# **REPORT TO CITY PLAN COMMISSION**

Plan Commission Meeting Date: January 11, 2016

**Item:** Preliminary Plat – Pond View Estates

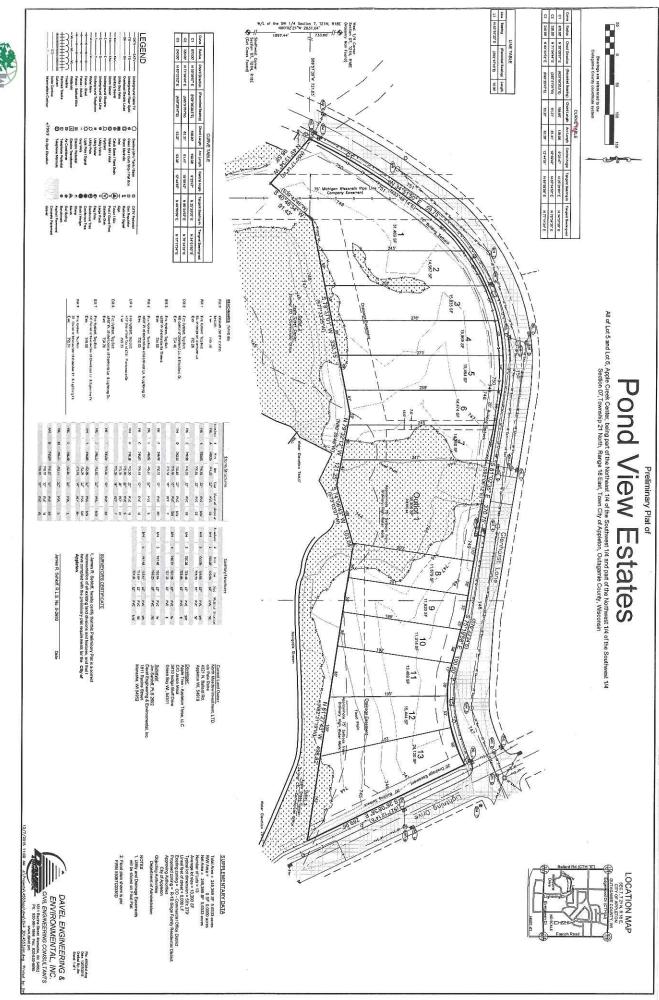
- 2. All easements, including but not limited to, water mains, sewer mains, storm sewers, and drainage shall be shown on the Final Plat to the satisfaction of the City Engineer per Section 17-12(b)(5) of the Municipal Code. Note: Provide a water main easement that has a 10 foot offset from the centerline of Glenhurst watermain. See attached map.
